Airworthiness Directive Schedule

Engines

Continental IO-550 Series and TSIO-550-K Series

27 August 2020

DCA/CON/174 Oil Filter Adapter Assemblies - Inspection

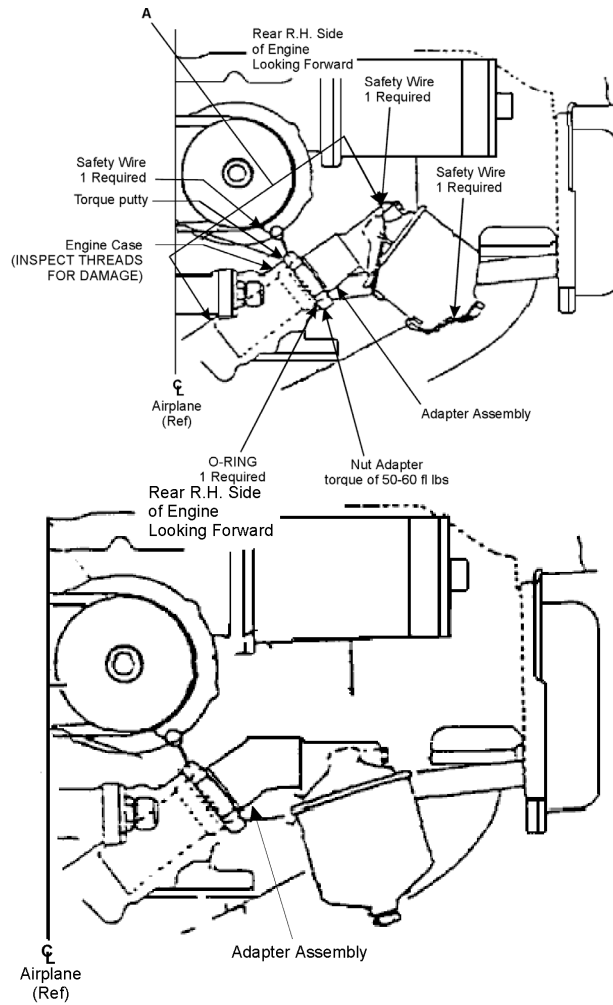
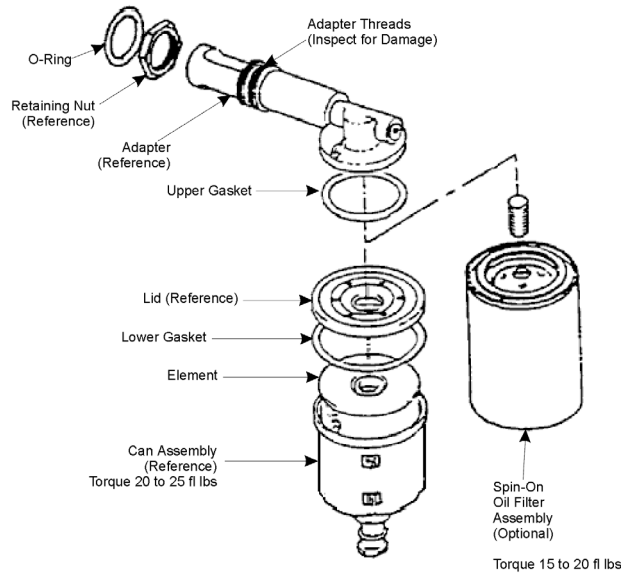
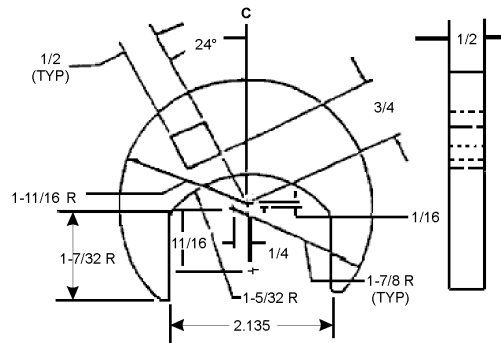
1. For oil filter adapter assemblies that do not have torque putty between the engine filter adapter assembly, nut, and oil pump housing, accomplish the following:

- (a) Inspect the adapter locking nut installation for evidence of oil leakage.
 - (b) Check the torque of the adapter nut installation and ensure that the torque value is within the limits of 50 through 60 foot pounds.

- (c) If evidence of oil leakage is found or the torque is not within the 50 through 60 foot pound limit, prior to further flight, remove the adapter and filter assembly, and:

- (i) Inspect the threads of the adapter assembly and engine for signs of damaged or cracked threads; and
 - (ii) Replace any adapter assembly and engine oil pump housing (if necessary) that have evidence of thread damage or cracks.

- (d) Apply torque putty between the engine filter adapter assembly, nut, and oil pump housing as specified in the diagram.
 - (e) Reassemble the engine oil filter assembly.

2. For oil filter adapter assemblies that do have torque putty between the engine filter adapter assembly, nut, and oil pump housing, inspect the torque putty for misalignment, evidence of oil leakage, or cracks.

If any misalignment, evidence of oil leakage, or torque putty cracks are found, prior to further flight, accomplish the requirements specified in paragraph (1) of this AD, including all subparagraphs.
